Product Update

#P136F

Revision 02

CONCEALED VERTICAL ROD/ CABLE EXIT DEVICE APPROVAL FOR 45-, 60-, AND 90-MINUTE POSITIVE PRESSURE FIRE DOORS

Figure 1

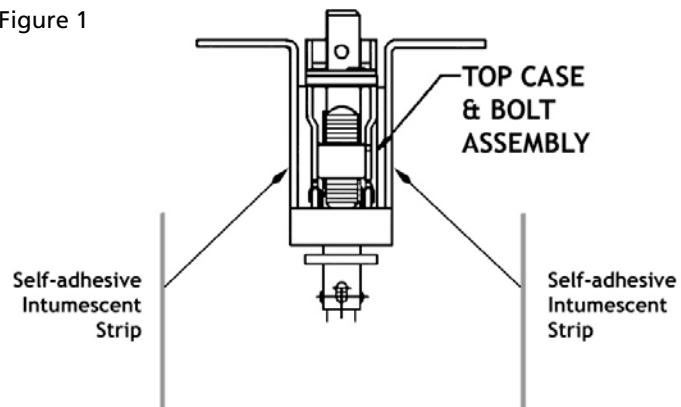
1. 5" legged metal channels at the meeting stiles
2. Top latch bolt lined with intumescent, as supplied by VT (see Figure 1).

1. Clean any oil, dirt, or residue from the device.
2. Cut or break the intumescent to the correct length.
3. Remove the protective paper backing.
4. Apply the adhesive-backed intumescent to the edges on either side of the CVR top latch as shown.
